PIC16C54C/55A/56A/57C/58B (Rev. A Silicon) Errata Sheet

The PIC16C54C/55A/56A/57C/58B **(Rev. A Silicon ONLY)** parts you have received conform functionally to the PIC16C5X Device Data Sheet (DS30453**D**), except for the anomalies described below.

FIGURE 1: $\overline{\text{MCLR}}$ EXTERNAL CIRCUIT

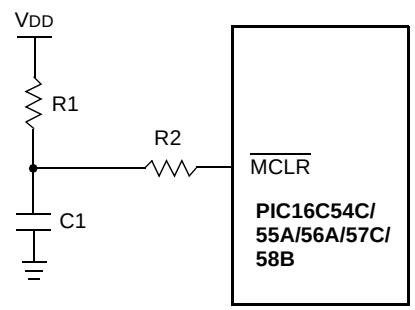
1. Module: RESET

The minimum specification for the $\overline{\text{MCLR}}$ must be met in order to RESET the PIC16C54C/55A/56A/57C/58B. If a $\overline{\text{MCLR}}$ pulse occurs that is less than the minimum specification (parameter #30), improper device operation can occur.

If the minimum specification cannot be met, then an external circuit must be used to ensure that any pulse width, less than the specification, will be filtered before it reaches the $\overline{\text{MCLR}}$ pin.

4.7KW ≤ R1 ≤ 10KW
0.0µ1F ≤ C1 ≤ 0.1µF
R2 = 100Ω

A possible circuit is shown in Figure 1. Proper design validation needs to be done to ensure desired operation over the applications operating conditions.
